Access Compliance Report Public Rights-of-Way (Curb Ramps)

Intersection ID: N/A Main Street: BRIAR CREEK RD **Cross Street: N/A** Location: SW ADA ID: 892DA4C2D296 Ramp Type: ParaDiag Initial Pass/Fail: Fail **Overall Compliance: No Severity Score:** 25

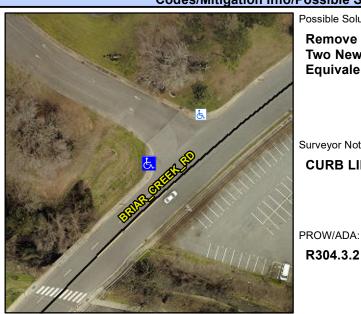
Possible Solutions: **Remove & Replace Curb Ramp With** Two New Directional Ramps or Equivalent. Surveyor Notes: **CURB LIP 0.5, RT RP < 5%**

R304.3.2
